# HARTING Product Change Notification

**PCN/18/014/C+N**

**Product range:** DC1 / D-Sub

**Title:** D-Sub hoods with straight cable entry and screw locking - External

(Image shows the 9-pole plastic hood and is for illustration purpose only)

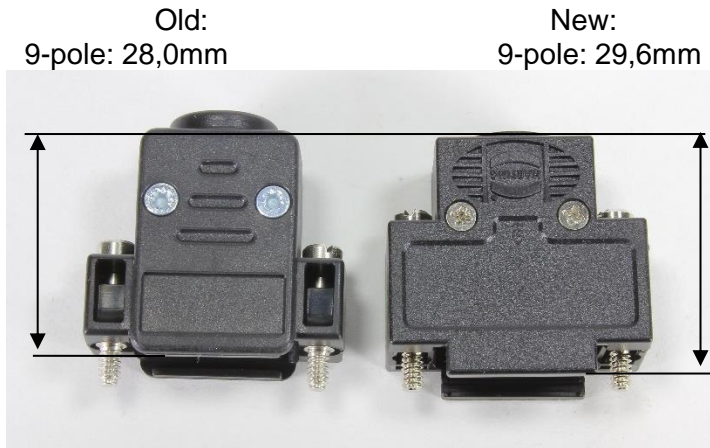
- HARTING-Logo:

Old: no HARTING Logo

New: molded HARTING Logo

- Locking screw preassembly

Old: locking screw preassembled  
in the cover

New: locking screw preassembled  
in the hood
